Project	IEEE 802.16 Broadband Wireless Access Working Group <http://ieee802.org/16>	
Title	Framework for Enabling Closed-loop MIMO for OFDMA	
Date Submitted	2005-01-11	
Source(s)	Wonil Roh, JeongTae Oh, Chan-Byoung Chae, Kyunbyoung Ko, Hongsil Jeong, Sung-Ryul Yun, Seungjoo Maeng, Jaeho Jeon, Jaeyeol Kim, Soonyoung Yoon	wonil.roh@samsung.com Voice: +82-31-279-3868
	Samsung Electronics Co., Ltd. Erik Lindskog, Harold Artes, Djordje Tujkovic, Kamlesh Rath, Andreas Bergkvist, V. Shashidhar, B. Sundar Rajan, Rahul Vaze, Bob Lorenz, Babu Mandava, A. Paulraj, Aditya Agrawal	elindskog@beceem.com Voice: +1-408-387-5014
	Beceem Communications, Inc. Young-Ho Jung, Seung Hoon Nam , Jaehak Chung, Yungsoo Kim, Sung-Jin Kim, Hojin Kim	
	Samsung Advanced Institute of Technology Wen Tong, Peiying Zhu, Ming Jia, Dongsheng Yu, Hua Xu, Jianglei Ma ,Mo-Han Fong, Hang Zhang, Brian Johnson	
	Nortel Networks Qinghua Li, Xintian Eddie Lin, Shilpa Talwar, Randall Schwartz, Sumeet Sandhu

Abstract	Framework for Enabling Closed-loop MIMO for OFDMA
----------	---

Purpose	Adoption of proposed changes into P802.16e
---------	--

Figure 231c - Mapping of MIMO coefficients for quantized precoding weight for enhanced fast MIMO feedback payload bits

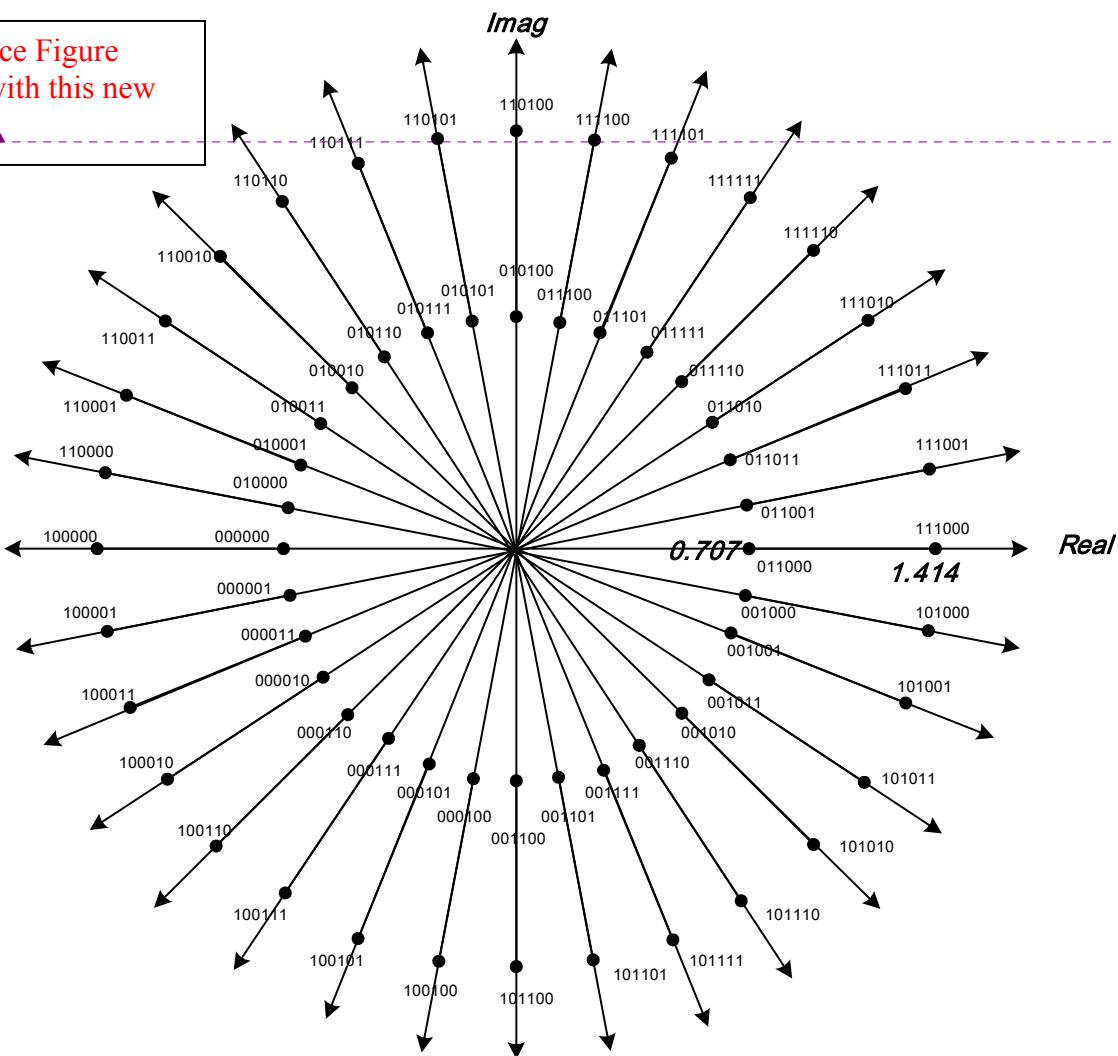
8.4.5.4.10.6 Fast MIMO Feedback of Quantized Precoding Weight for Enhanced FAST_FEEDBACK Channel

When the FAST_FEEDBACK subheader Feedback Type field is ‘01’ or ‘10’, or the CQI Feedback Type field in the MIMO Compact DL-MAP IE() (see 6.3.2.3.43.6.7) is 011, or the CQI Feedback Type field in CQICH_Enhanced_Alloc_IE() (see 8.4.5.4.~~15+2+4~~) is 011, the MSS shall report the MIMO coefficient the BS should use for best DL reception (~~see 8.4.8.1.6~~). The mapping for the complex weights is shown in Figure 231c, and the SS shall construct the 6 CQI bits with 0 as the MSB and the mapped code as the remaining LSBs. For this type of feedback, if N is the number of BS transmit antennas, then (N-1) CQICH shall be allocated to the SS and SS shall report the desired antenna weights of antenna 1 through N-1 based on antenna 0.

[Replace Figure 231c with this new figure.]

Figure 2 H-ARQ Enabled Vertically Encoded 2x2 MIMO System

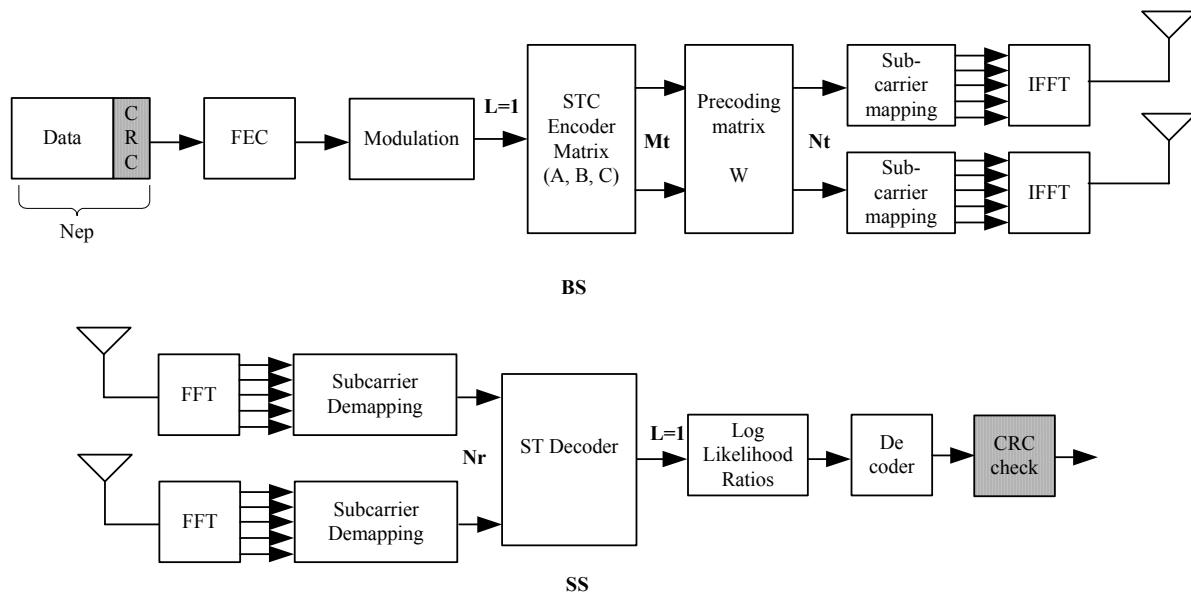
Some clarification is made on burst mapping for H-ARQ when multiple MIMO layers are transmitted on the same physical resource. The multiple layer transmission is enabled when spatial multiplexing (SM) schemes are employed with multiple modulation and coding blocks implemented for each spatial layer. We call it horizontal encoding (HE) and this mode enables adaptive rate control for each spatial layer. The other class of spatial multiplexing schemes is called vertical encoding (VE) and it features a common modulation and coding block. Transmit diversity (TD) can be also regarded as single layer technique. Figure 2 shows an example of 2x2 VE MIMO system, whereas Figure 3 illustrates that of 2x2 HE MIMO system. In both figures, L equals the number of layers, Mt the number of STC output streams, Nt the number of BS transmit antennas, and W denotes the precoding matrix. Their relations according to the current standard are tabularized in Table 1.

In both Figure 1 and Figure 2, when there is no precoding matrix at Tx, Mt becomes the number of transmit antennas. In Table 1, the existing open-loop matrices (A, B, or C) are noted and the superscript ¹ indicates the applicability of the antenna grouping technique.
